Item Name: Replacement Skidtube (Fits LH or RH)

DRAWING NO. D2650	TITLE 206/407 SKIDTUBE ASSEMBLIES	REV. F	DART AEROSPACE LTD ENGINEERING ORDER		D.E.O. NO. D2650-F-1	SHEET NO. SHEET 1 OF 1	SCALE NTS
DRAWN [Signature]	CHECKED A.P.	MFG. APPR. [Signature]	APPROVED [Signature]		DE APPR. [Signature]		
DATE 12.10.12	DATE 12.10.22	DATE 12.10.22	DATE 12.10.22		DATE 12.10.22

PURPOSE:

CHANGE C'BORED WELDED CROSSBOLT SPACERS TO SWAGED SPACERS

ADD DETAIL G BELOW, WHICH IS THE SAME SECTION VIEW AS DETAIL D OF DWG.

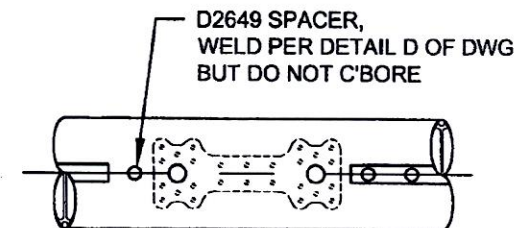
C'BORED HOLES ARE **NOW SWAGED** PER DETAIL G BELOW. FOR THE Ø0.375 HOLE THAT IS NOT C'BORED, WELD PER DETAIL D OF DWG (SEE AMENDED DETAIL B FOR REFERENCE).

AFTER DRILLING AND BENDING ASSEMBLY
PERFORM THE FOLLOWING FOR Ø0.375 HOLES THAT ARE
CURRENTLY C'BORED:

1. INSERT D4720-1 SPACER, 16 PL (-1) OR 17 PL (-3)
OR 19 PL (-5) OR 23 PL (-7)
2. SWAGE TO Ø0.313 X 0.75 DP PER QSI 002
3. TRIM / GRIND FLUSH PER QSI 002
